RE: ***City of Phoenix's Notice of Appeal of the Arizona Department of Environmental Quality's Publication and Listing of Indian Bend Wash, from its Headwaters to its Terminus, as an impaired water under Arizona's 2022 303(d) List of Impaired Waters; Request for Informal Settlement Conference; Request for Hearing***

ARIZONA DEPARTMENT OF ENVIRONMENTAL QUALITY
NOTICE OF APPEAL OF AGENCY ACTION
REQUEST FOR HEARING

CITY OF PHOENIX FOLLOW-UP CORRESPONDENCE

ARIZONA'S 2022 CLEAN WATER ACT ASSESSMENT

Figure 1. Aerial of sampling point in context to Indian Bend Wash channel.

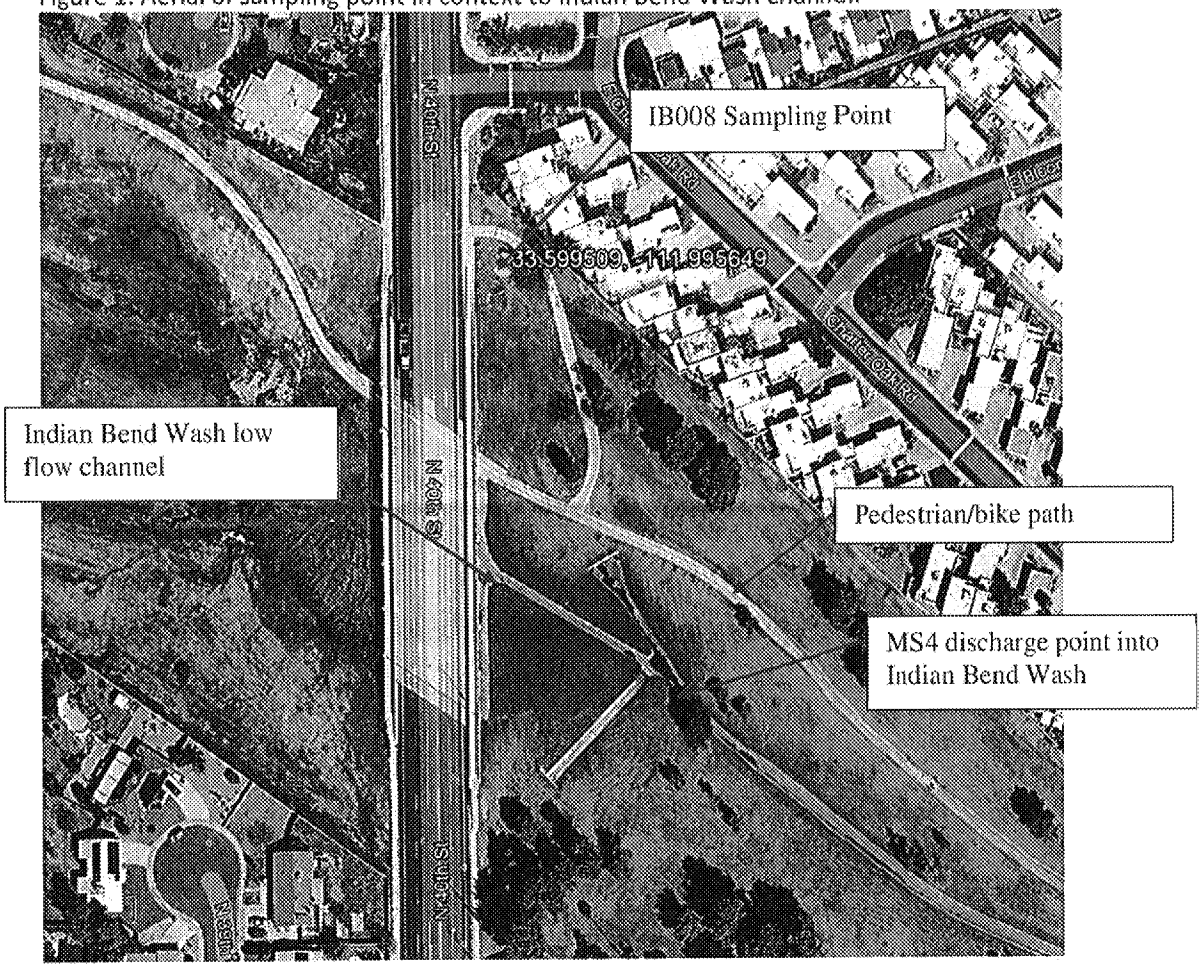
The IB008 wet weather sampling station is at 33.599509, -111.995649 and is not within the Indian Bend Wash channel. This sampling station is on top of the bank approximately 242 feet northwest of the point where the catchment discharge enters Indian Bend Wash. A buried pipe carries the discharge from the sampling station to the discharge point into Indian Bend Wash. This sampling point is not capturing information on the flow in Indian Bend Wash.
